Ivanhoe Hotel, Manly - Acoustic Advice for Revised Shopfront Scheme

This letter presents the results of a review of the proposed revised shopfront scheme for the ground floor areas of the Ivanhoe Hotel at 27 The Corse, Manly.

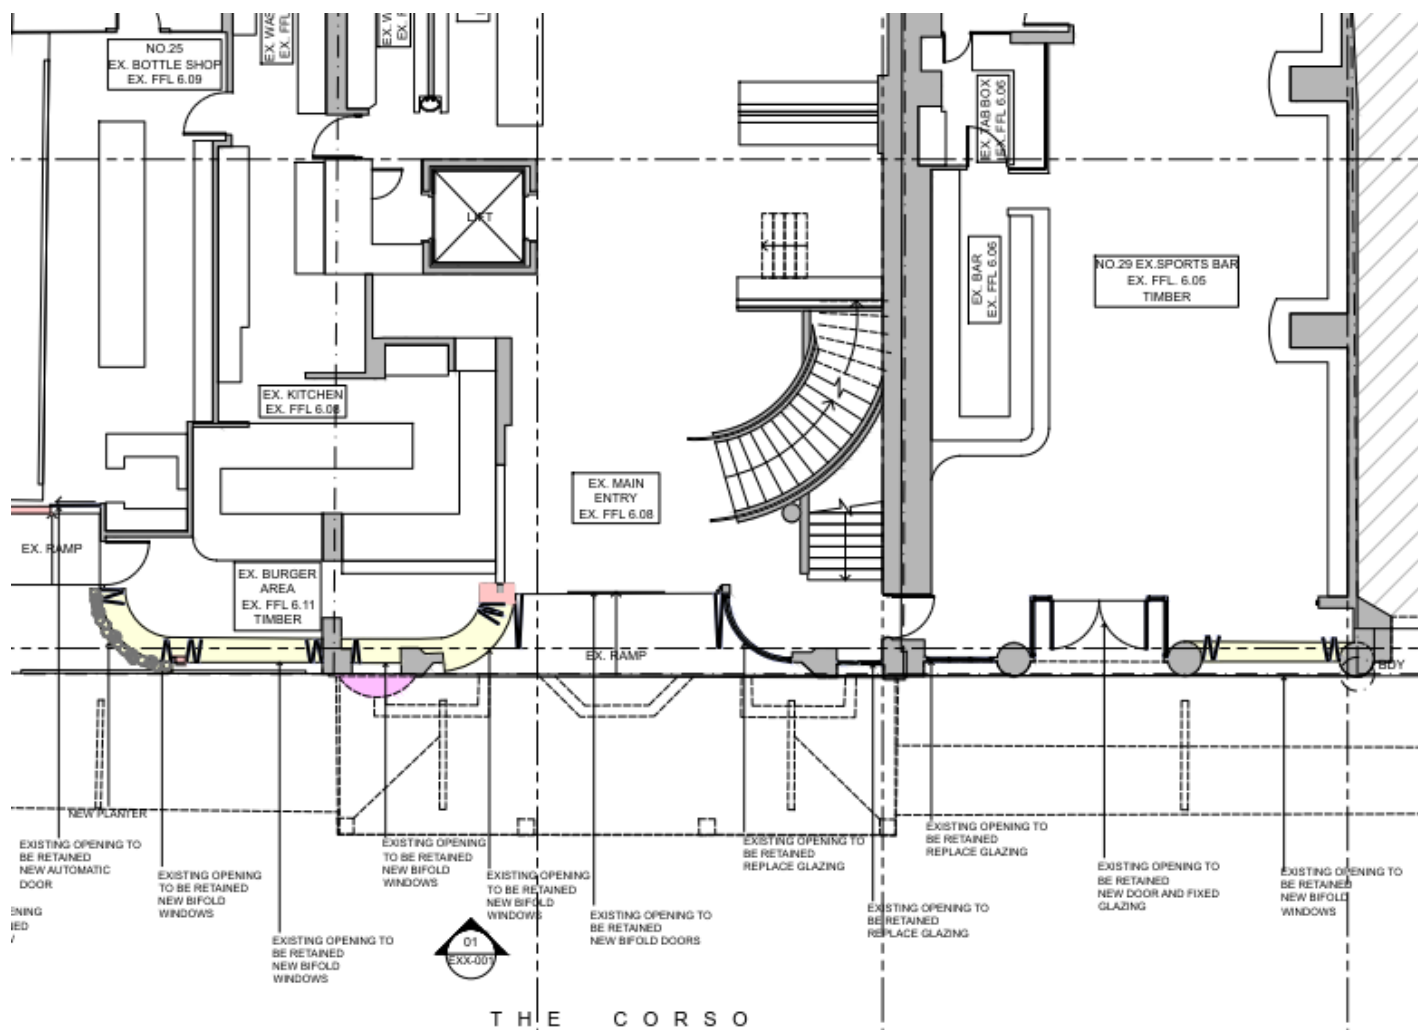
The following changes are proposed to the existing façade;

- **Main Entry**
 - Existing hinged double doors is proposed to be replaced by bi-fold doors. Operations of this element (i.e. open or close) of the façade must not change.
 - Existing fixed façade to the west of the entry door is now proposed to be replaced by operable bi-fold doors. These doors must remain close at all times between 6pm – 7am.

- **Sports Bar**
 - Double entry doors to be relocated to location of existing bi-fold doors. Operations of the entry door (i.e. open or close) must not change.
 - New operable bi-fold doors are proposed at the location of original double entry door. Operations of these doors (i.e. open or close) must follow the current operations of bi-fold doors to this area.

We recommend the following minimum constructions and management controls;

- All façade glazed elements must be of the same construction of existing or better (10.38mm laminate or 12.38mm laminate). Additionally, full perimeter rubber acoustic seals must be installed to all new bi-fold, sliding and hinger doors.
- New decorative timber cladding to be of the following minimum construction;
 - External timber cladding + 92mm steel studs with 75mm thick 24kg/m³ density glasswool insulation + 1 x 13mm plasterboard internally.
 - This section of the façade will perform better than the existing single glazed elements.
- **Bottle Shop**
 - Part of fixed façade is proposed to be replaced with operable bi-fold doors. These doors must remain close at all times between 6pm – 7am.
 - All other operable elements of the façade to maintain operations as existing.
